CITY OF ALBUQUERQUE

**Re: Vistas at Seven Bar Apts. Driveway Relocation Paving Plan
Engineer's Stamp dated 9-7-10 (A13/D002)**

VISTAS @ SEVEN BAR APTS. DRIVEWAY RELOCATION	DRAWN BY BY
	SITE PLAN AND PAVING PLAN	DATE 9-01-10
TIERRA WEST, LLC 5571 MIDWAY PARK PLACE NE ALBUQUERQUE, NM 87109 (505)858-3100 tierrawestllc.com	SHEET # C1	JOB # 29066

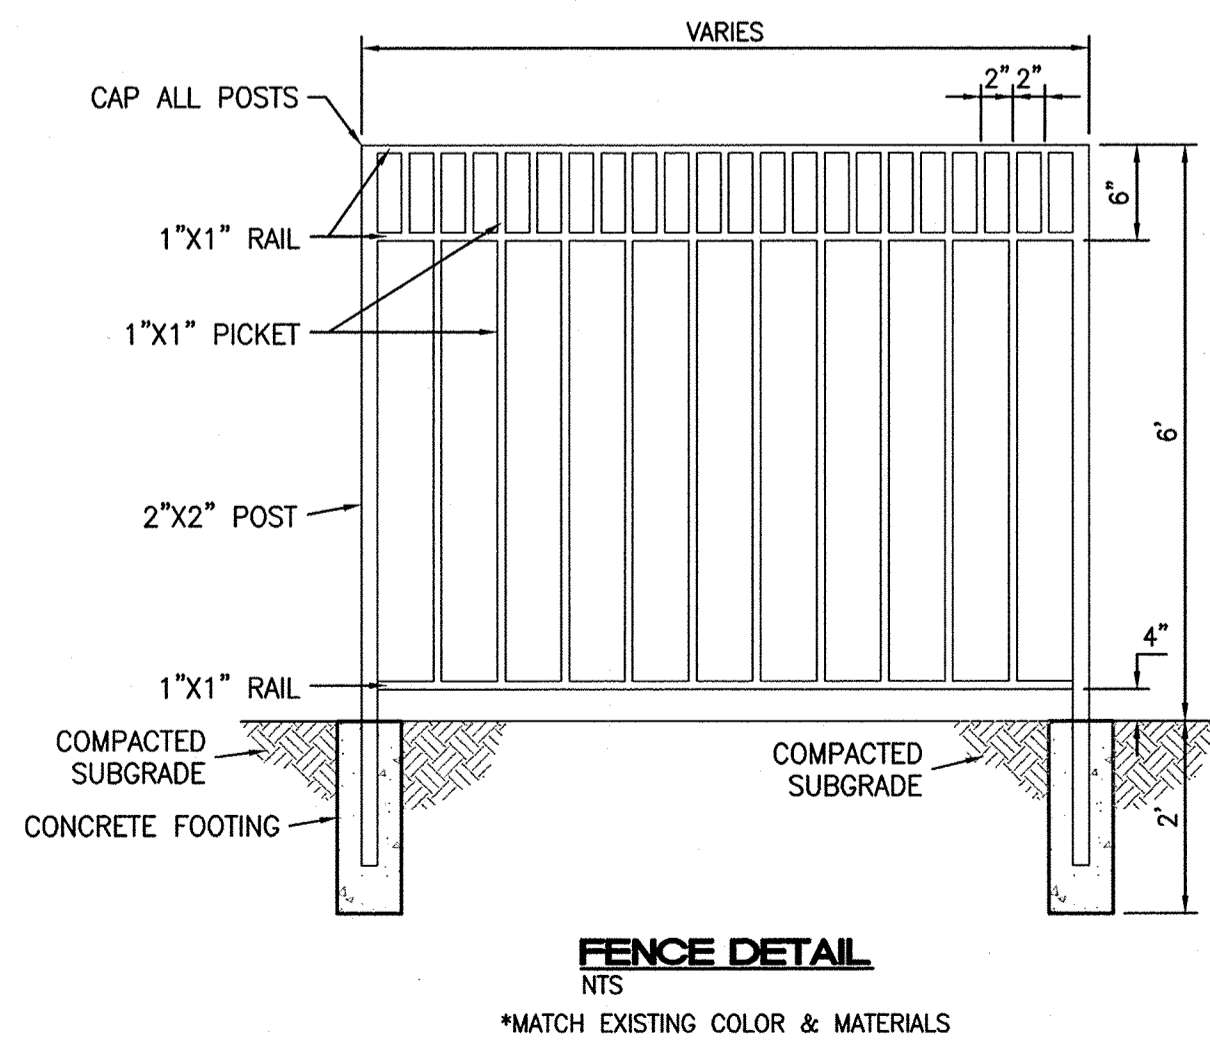
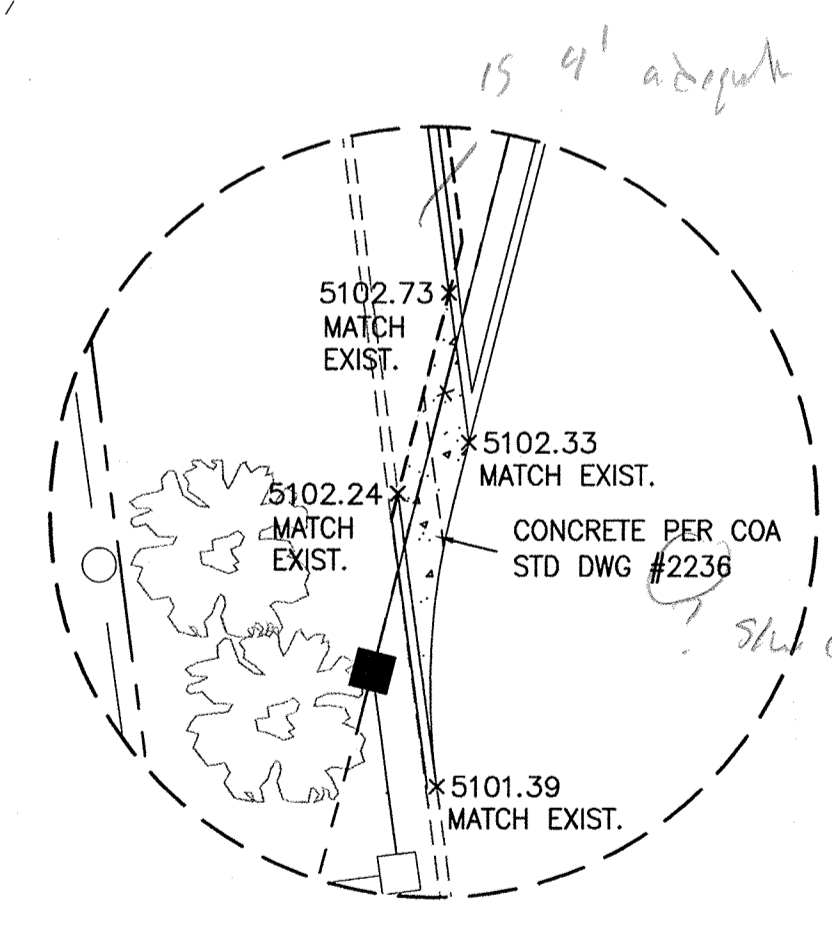
- It is difficult to tell if the 4 foot wide channel provides adequate capacity. Why build the 6" AC berm that greatly reduces the channel width?
- A detail should be provided for the 4 foot concrete channel that specifies depth, concrete thickness, and steel if any.
- Detail "B" specifies concrete per COA STD DWG 2236. Is there to be an invert in the channel?
- It is not clear if there is enough water block on the downstream high point of the proposed drive pad (00.49).
